Product Change Notification

1. ECR #: 207931
Notification #: 602

3. Series:
• ERF6 ASSEMBLY

5. Description of Change:
ERF6 is being transferred to Samtec's vision inspection platform

Old Design (.098 diameter K-Dot) vs New Design (.118 diameter K-Dot)

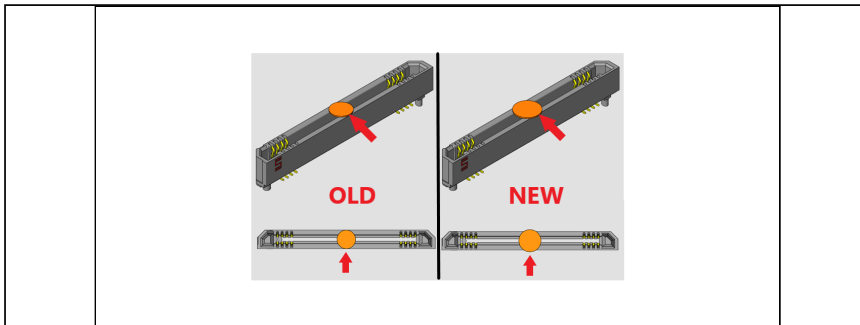
6. Method of Identifying Change
K-Dot diameter changed from .098" to .118"

7. Reason for Change:
The change was made to improve quality & manufacturability at Samtec

8. Impact of Change on Form, Fit, or Function:
• Form - Increased K-Dot size
